professional
products division**SERVICE BULLETIN**

Date: May 18, 1959
Model: 300
Bulletin No: Index
Page No: 1

TYPICAL SIGNAL VOLTAGES, MODEL 300 ELECTRONICS CATALOG NUMBER 559

ADJUSTMENT OF AC SOLENOIDS ON RECORDERS BELOW SER. NO. 500

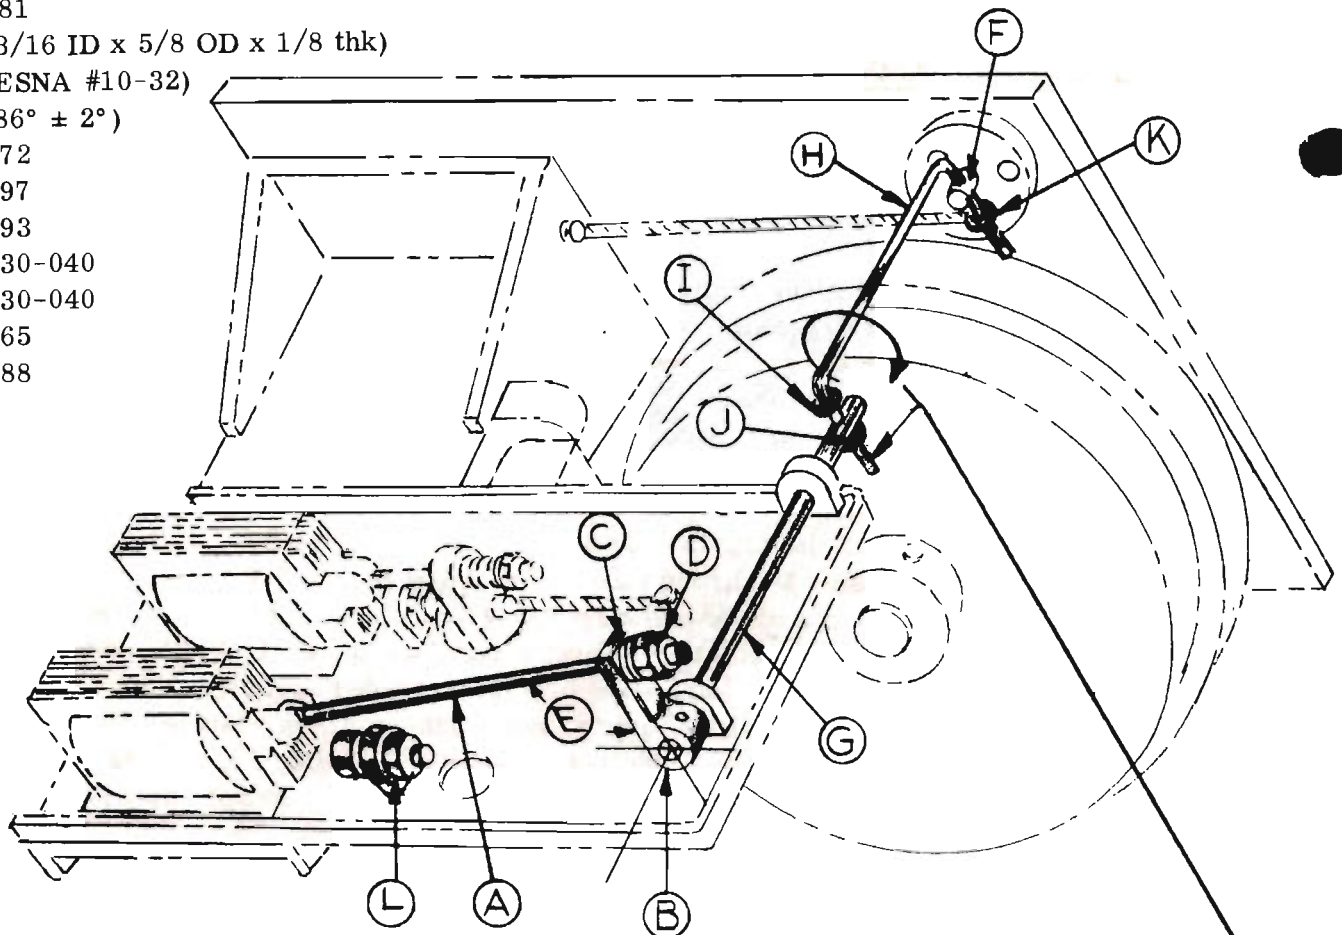
Some difficulty has been experienced with the humming or buzzing of the #020-005 AC solenoid which operates the capstan idler, K501. Investigation of the cause of this noise has disclosed that if the linkage has not been adjusted properly, the force required of the solenoid will be greatly increased and therefore cause it to hum.

Looking at the drive assembly from the bottom, the linkage of the capstan idler solenoid can be seen. The link rod A passes through a hole in the arm B that it operates, and there is a rubber washer (C) and adjusting nut (D) on the end. When the solenoid is operated, the rod pulls the rubber washer against the arm to operate it. When the solenoid is seated, the angle E between the rod and the arm should be less than 90°. If this is so, the effective contact point of the washer is on the outside. If the angle between the rod and the arm is greater than 90° when the solenoid is seated, the contact point of the washer on the arm is on the inside, effectively reducing the moment arm by a considerable amount, and therefore requiring much greater force to be exerted by the solenoid.

The importance of maintaining the above angle E below 90° was only recently discovered, and it is possible that some machines have been shipped in which this angle might be too great. While no machines have been shipped with noisy solenoids, it is possible that if the above adjustment is not proper the solenoids may become noisy in use. Should this be the case, the adjustment can be corrected as follows:

It will be noted that the capstan idler arm shaft F is connected to the operating shaft G below through a U-shaped torque link H. If the bottom (or shorter) arm of this link H is bent in a clockwise direction (when looking at the link from the bottom or short arm end), this will effectively reduce the angle E. In order to bend this arm, it is necessary to remove link H and hold it in a vice. The link can be removed by forcing off the spring-lock washers which position the lower arm (I and J) and which attach the return spring at the top (K). The proper value for the angle E is approximately 86°, or when the arm B is perpendicular to the plane of the solenoid base plate.

ANGLE E MUST BE LESS THAN 90° WHEN
CAPSTAN SOLENOID IS SEATED.

TO REDUCE ANGLE E, BEND
THIS ARM CLOCKWISE WITH
RESPECT TO UPPER ARM.
RESET ADJUSTING NUT D & L.

If the angle E is changed, it will be necessary to re-set the capstan idler adjustment D. This adjustment is set so that when the capstan idler just touches the capstan, the solenoid is 1/8 inch shy of seating. A simple way of making this

setting is to place a piece of material 1/8 inch thick between the solenoid armature and body and clamp the armature down on it. Then tighten the nut D until the capstan idler just touches the capstan.

It may also be necessary to reset the capstan idler solenoid Stop L. This stop should be set so that at no time during fast winding does the tape touch the capstan idler.

PLUGGING OF CAPSTAN OIL
HOLE ON RACK MOUNTED
UNITS

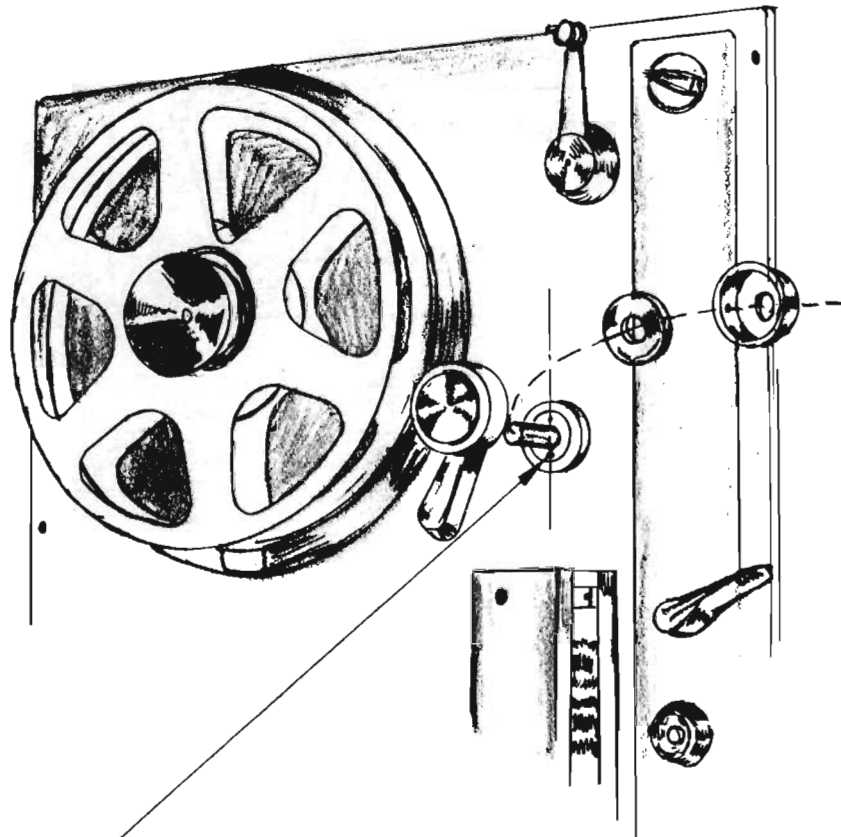
1. Capstan Oil Leakage. There is a tendency for oil to climb out of the capstan bearing housing during the first few weeks of operation. The capstan bearing has been thoroughly impregnated with oil so as to drive out any air inclusions, as the presence of air would tend to force oil out of the bearing housing when it becomes warm. The excess oil present climbs up the capstan when the machine is operated. Ordinarily, this oil is caught by the felt washer on top of the bearing housing. (The neoprene washer shown in fig. 2 of the instruction book was eliminated in production because it produced flutter.) If this washer becomes saturated with oil, which usually happens, then it will no longer behave as an effective seal. Therefore after the first week or so of operation, when most of the excess oil has had a chance to work out, the felt washer should be removed and washed out in carbon tetrachloride. Simply remove the capstan dust cap (see fig. 2, instruction book) to remove the felt washer. If this washer is kept reasonably dry, then no trouble should be experienced with oil creeping up the capstan.

REMOVE CAPSTAN DUST COVER
& FELT WASHER AS SHOWN
POSITION CAPSTAN ASSEM.
SO THAT CENTER LINE BETWEEN
BOTH HOLES IS VERTICAL WITH
LARGE C'SK HOLE ON THE
BOTTOM AS SHOWN. IF CAPSTAN
SHOULD NEED POSITIONING SEE
SVC. BULL. #14
TAP 6-32 N.C. IN LARGE C'SK HOLE
INSERT 6-32 X 1/4 LG. FLAT HD. MACHINE
SCREW.

ADAPTING TURNABLES TO USE CATALOG #1917 EDITING KNOBS ON EARLY MACHINES

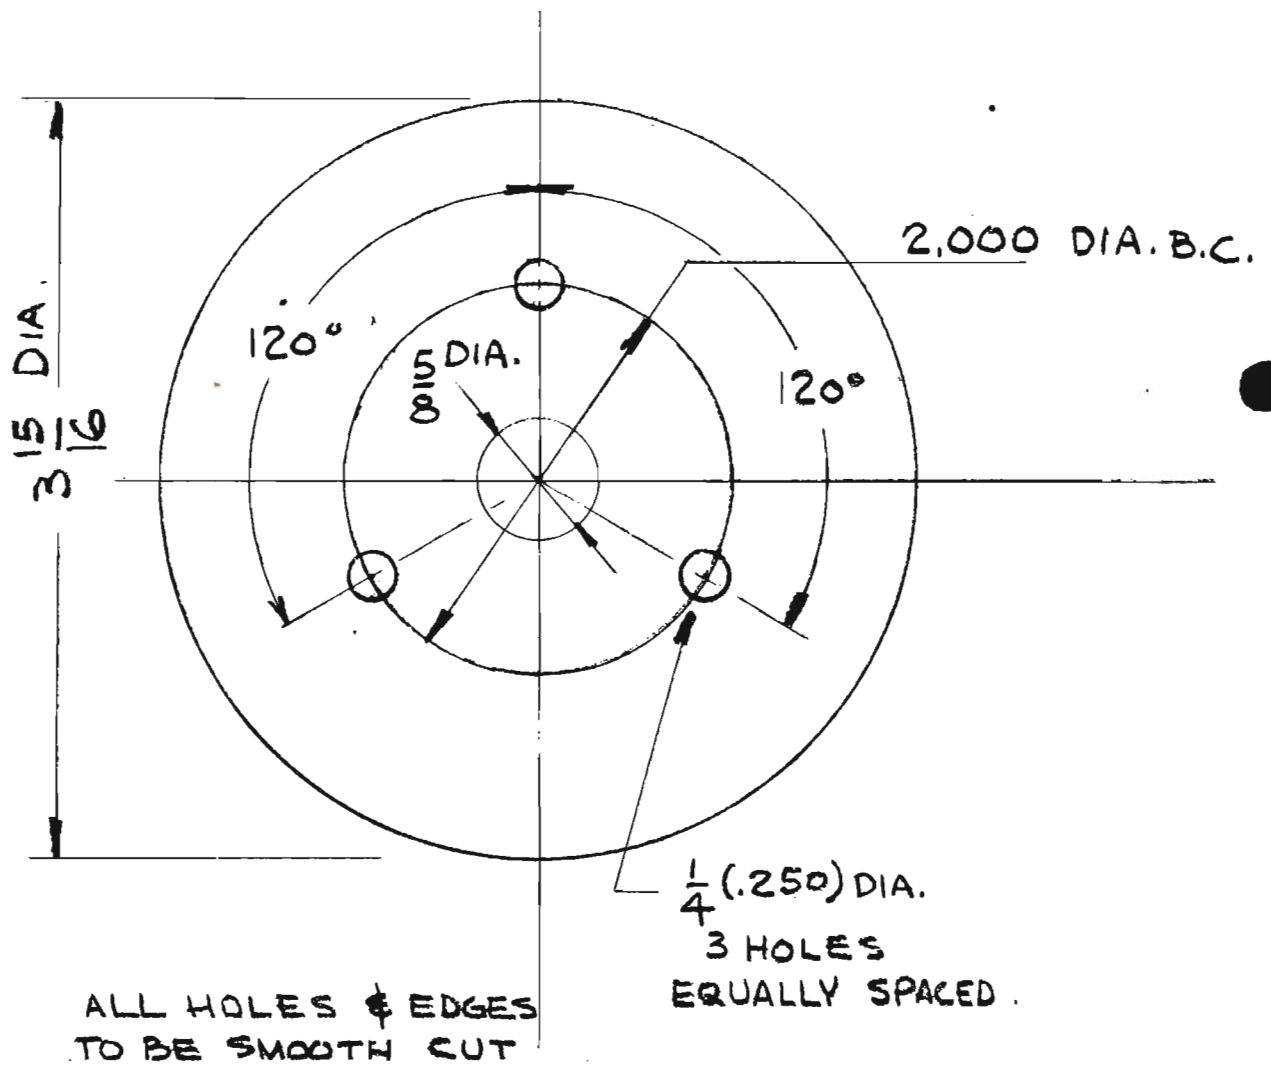
If it is desired to use the new editing knob assemblies, catalog #1917, with a Model 300 recorder which does not have the holes drilled in the turntable, the attached drawing will serve as a template diagram for drilling these holes.

When drilling these holes care should be taken that metal filings do not fall into the end-bell of the turntable motor. This can be accomplished by wrapping a cloth around the end-bell on the under side of the top plate while drilling.

PLAYBACK AMPLIFIER
MODEL 300 MODIFIED FOR 15-30 IPS
AMPEX CORPORATION
REDWOOD CITY, CALIFORNIA

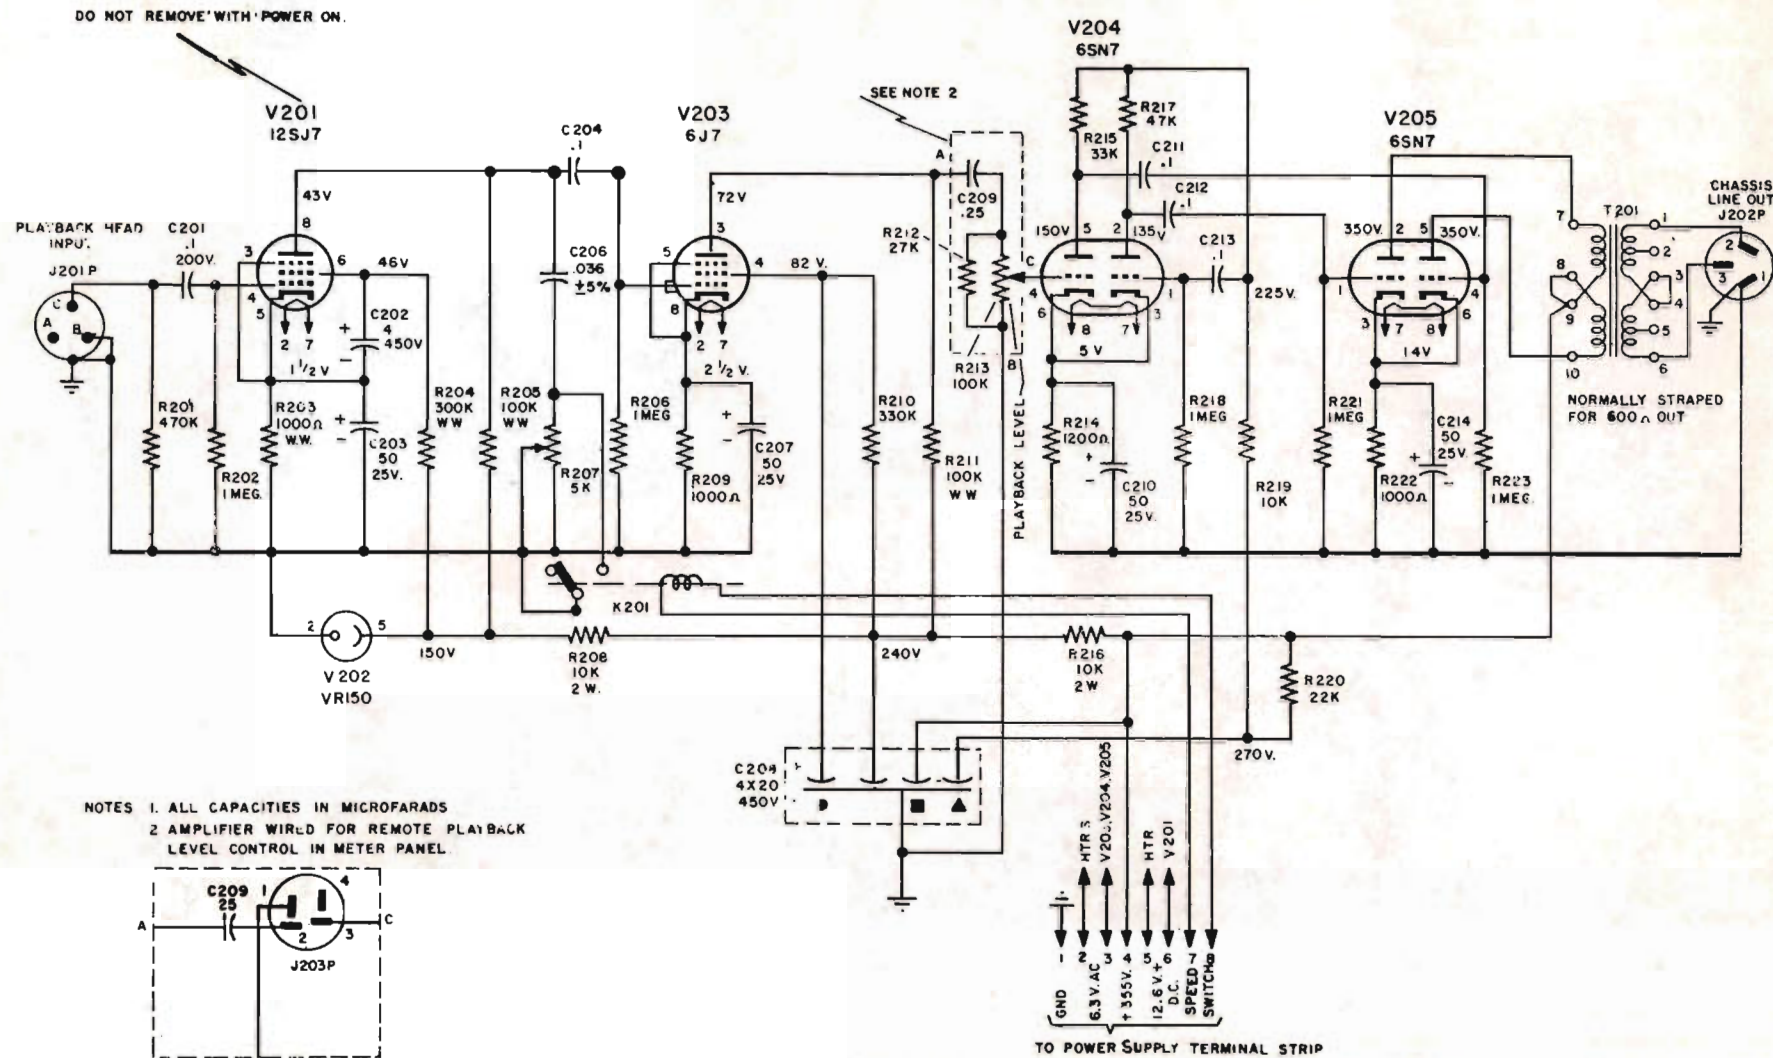
One of the standard modifications of the Model 300 is a conversion to run at 15 and 30 inches per second. The difference in speed is accomplished by changing the diameter of the motor pulley. A lower mass flywheel is required on the reel idler.

The electronic alterations consists of incorporating relays which operate from the Speed Change Switch. At the 30 ips speed, the relays operate to alter the equalization characteristics in accordance with the requirements of the higher speed.

Add Ampex #020-011 Relay, connecting coil to pins 7 and 8 of power supply terminal switch.

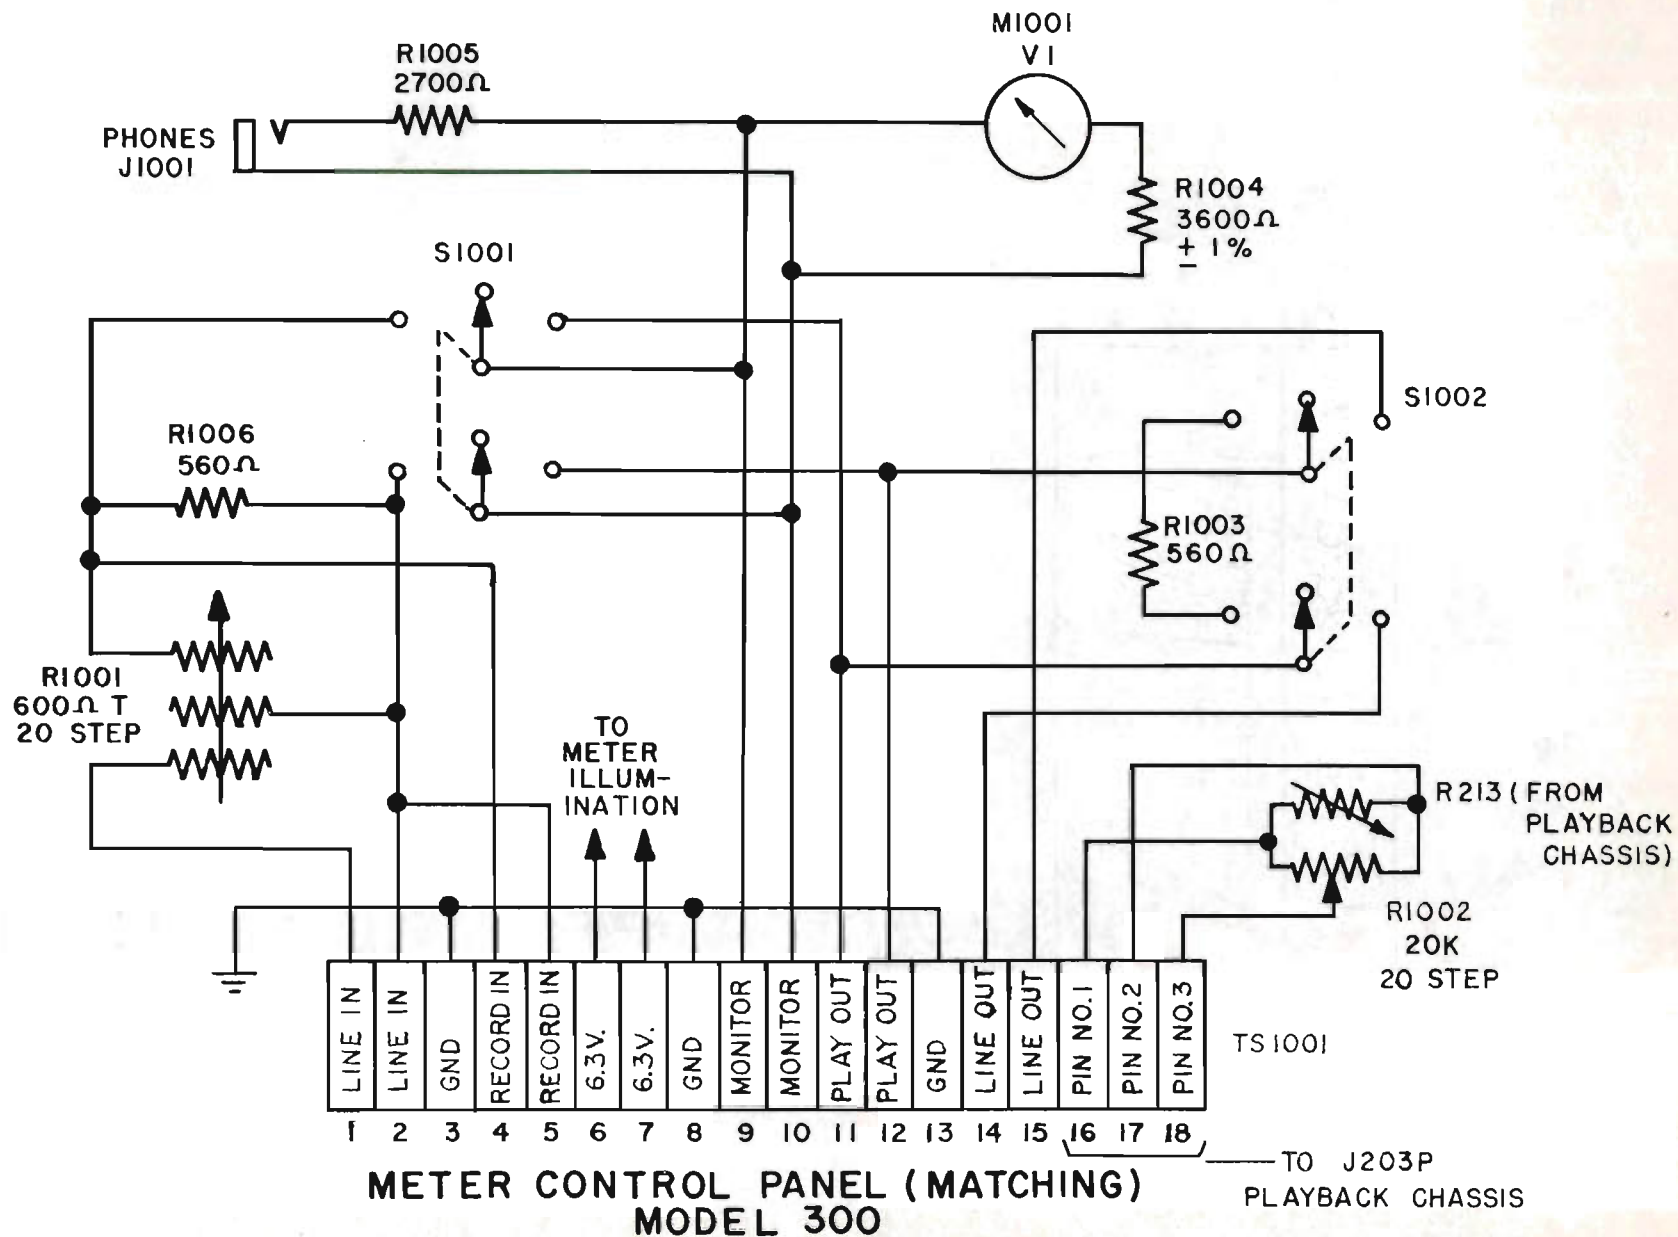
In order to switch the VU meter of the 515 meter control panel to read either input or output of the Model 300 recorder, it is necessary to use a matching meter control panel with the circuitry shown in the attached figure. The parts required are as follows:

In addition to installation of the above parts in the input circuitry, note that the meter and its associated resistor R1004 are now connected across monitor line.

FIGURE I

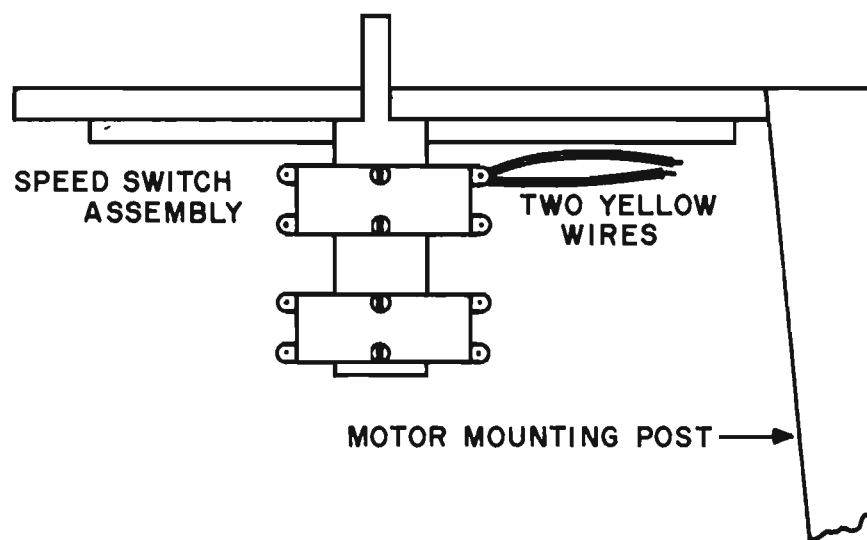
When a Bodine motor is replaced with the new wiring standard motor, the two yellow wires going to the speed change switch nearest the top plate must be removed from the switch, soldered together, and taped over. In the case of replacing a new wiring standard motor with a Bodine motor, the two yellow wires will be found taped together in the harness. These must be soldered to the speed change switch as shown in Figure 1.

Model 300 transports with serial numbers below 700 used Cyclohm or EAD motors. In order to replace these motors, the instructions given in service bulletin #14 should be followed prior to any changes noted in this bulletin.

FIGURE I

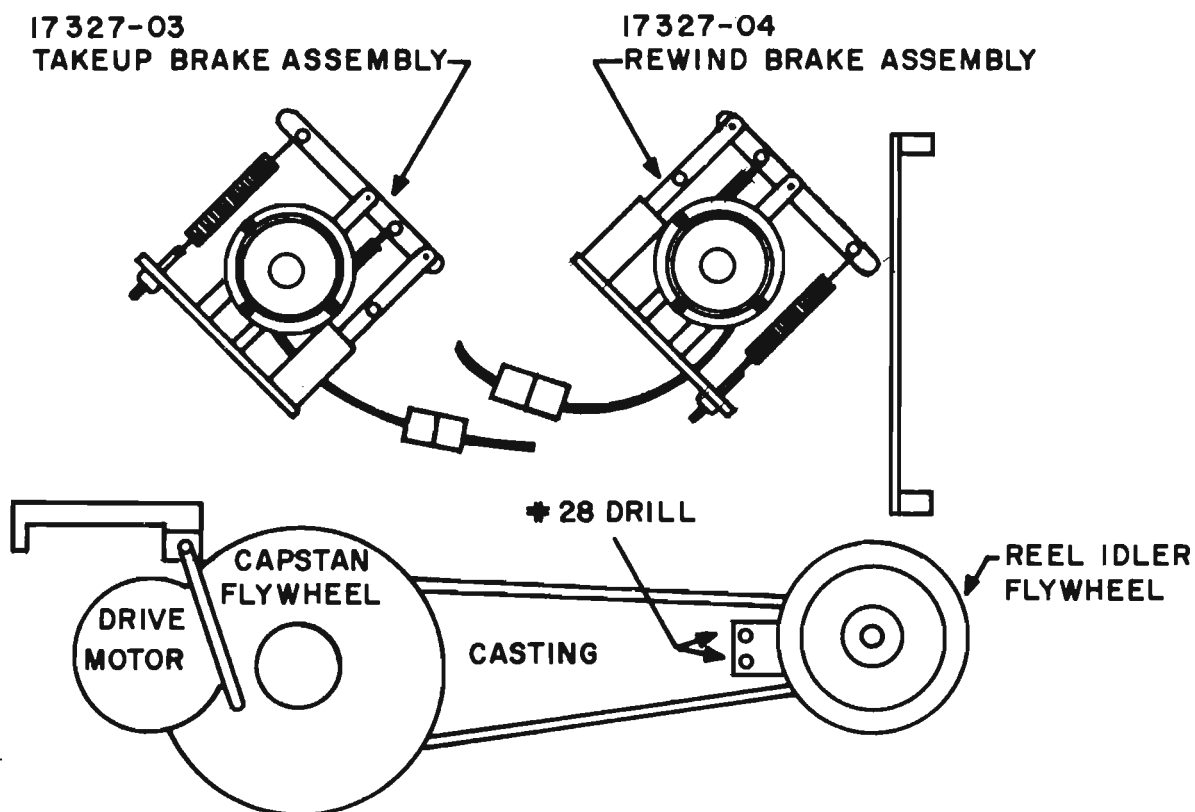
In reference to transport assembly, the procedure for making this change is as follows:

1. Remove capstan idler assembly by loosening Allen set screw in end of idler arm.
(See Figure I)
2. Turn tape transport upside down, if console type, and block so that weight is not resting on turntable shafts. If rack mounted, leave in rack.
3. Note two (2) holes, one (1) inch apart in top plate subassembly and in top plate backing panels near opening for reel idler.
(See Figure II)
4. Drill two (2) holes through top plate facing panel with a #28 drill, using the two (2) holes noted in #3 above as guides.
5. Install #6050 rotary tape guide using #6-32 machine screws supplied.
6. Slip back the insulating sleeves on the solenoid and capacitor wires. Disconnect the QUIK-CLIP connectors.
7. Remove the three brake assembly mounting screws.

8. Remove the supply turntable brake assembly and replace with the new 17327-04 brake assembly.
9. Remove the take-up turntable brake assembly and replace with the new 17327-03 brake assembly. These brake assemblies are factory adjusted and further adjustments should not be necessary. However, if they are, see service bulletin #6. (Enclosed with kit.)
10. Replace 1/4" tape guide on take-up tension arm with 1/2" tape guide supplied.
11. Install the new capstan idler assembly.

NOTE: Reel idler tension arm and associated 1/4" tape guide may be removed; however, they do not interfere with 1/2" operation.
